Planning Commission
September 21, 2021 – 6:00 p.m.
233 South Main Street, Monroe, Ohio

TO: Members of the Monroe Planning Commission
FROM: Kevin Chesar
Director of Development

DATE: September 21, 2021
RE: Information Packet for September 21, 2021 Planning Commission Meeting at 6:00 p.m.

I. Case No. 2021-1-1 (TABLED)—Consideration of a Site Plan for Thornton’s

Figure 1211-D: This photograph illustrates how a sidewalk connecting the public sidewalk to the business entrance shall be provided with the required landscaping.

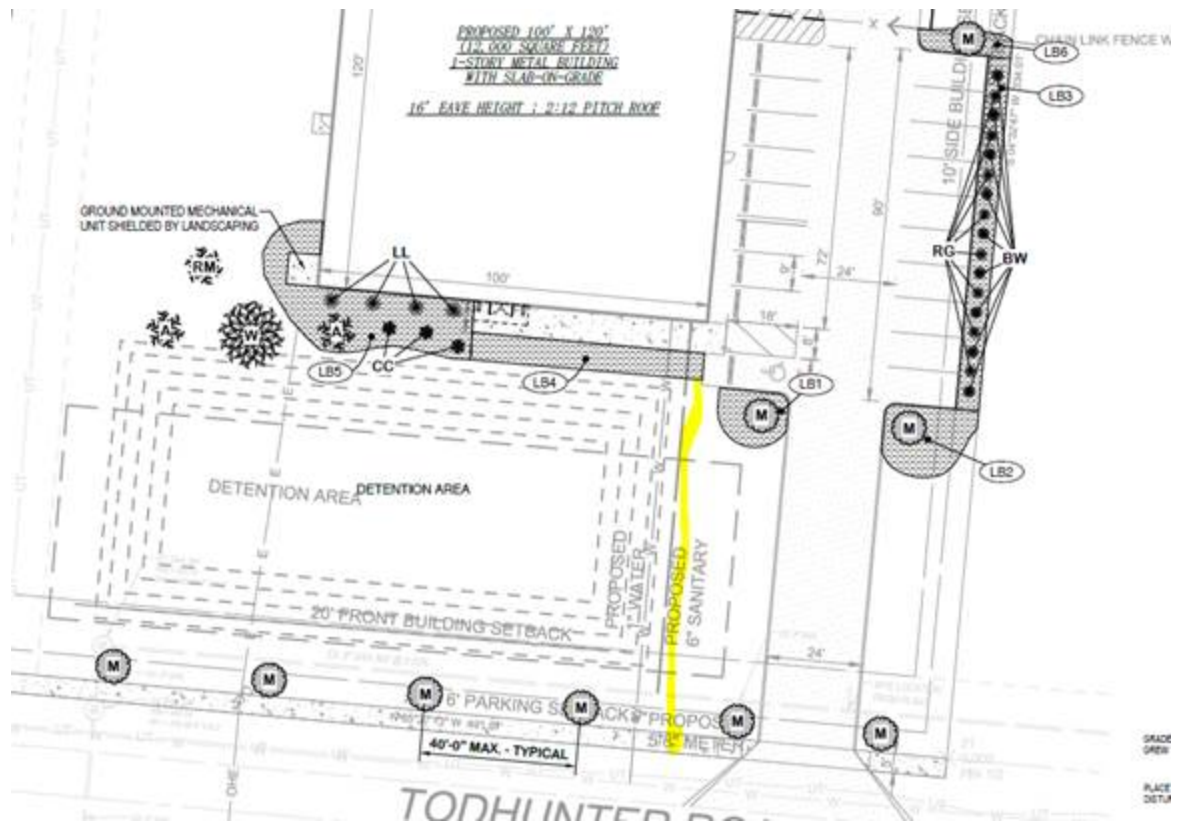
- Sidewalk Connection is required from the public street sidewalk to the building. Please revise. Below is a suggestion that would be one appropriate location (yellow highlight): **Will show walk as requested.**
